Authors' response to reviewer 1

Figure 1: Final energy gain in FLORIS on the left and in FAST.Farm on the right

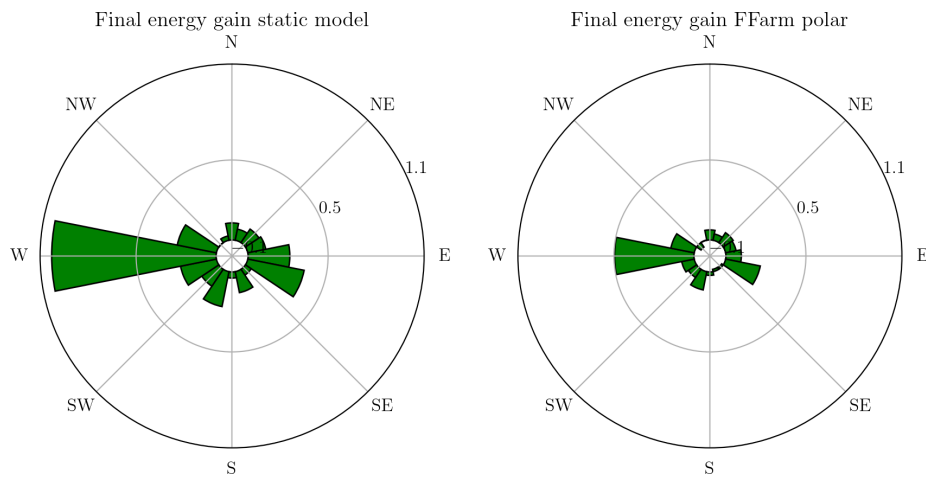
Line 275 - the gain of 1.4% might be within the modelling error and is insignificant

Thank you for this comment. We have added context to explain why the 1.4% gain is significant.

- The 1.4% is a small value when we do not consider the value of the wake losses. However as shown in Table 4 newly added to the text the new design leads to decreasing the wake losses from -6.08% to -4.73%. This decrease is equivalent to a decrease of wake losses by 22%. The gain in our work is only 1.4% because we used the optimized wind farm layout OWFL as a baseline for comparison. We decided to do this instead of using a gridded shape layout to truly show the benefit of relocating the FOWT. Starting with a gridded shape layout would lead to a much higher gain value as the gridded layout has higher losses. We are currently working on a paper showing that for wind farm layouts that are gridded shaped similar to the Horns Rev I wind farm, this method has a much higher potential as any small relocation will significantly increase the power. Tables 3 and 4 are now added to the text to show the wake losses of each layout.

- There is a big uncertainty from the wake model implemented within FAST.Farm as we discuss in the paper. However, FAST.Farm currently underestimates the wake losses for a FWF. As we discussed in the paper the work done in [3], compared the FAST.Farm results to MIRAS-HAWC2 results. The results show that FAST.Farm over estimates the vertical deflection of the wakes due to the pitching of the FOWT. This overestimation decreases the wake losses predicted by FAST.Farm and this is explained in section 3.4. Therefore, the uncertainty in the wake model decreases the

energy gain due to relocating the FOWTs and does not increase it.

- In Figure 11, that we zoom in and introduce again here, the final gain expected from the static model and the gain from FAST.Farm follow the same pattern. If the gain was due to numerical uncertainty the gain distribution over the wind directions will be random and would not agree with the predictions of the static model. This is explained in the paper in section 3.4 in line 290. The text is now updated as follows: “The energy gain distribution per wind direction in the FAST.Farm model follows the same trend as the gain distribution for the MoorPy-FLORIS results. This shows that the energy gain achieved by the OWFL when coupled to the OWFL, is not numerical as it is not random but follows our expectations from the steady state model.”
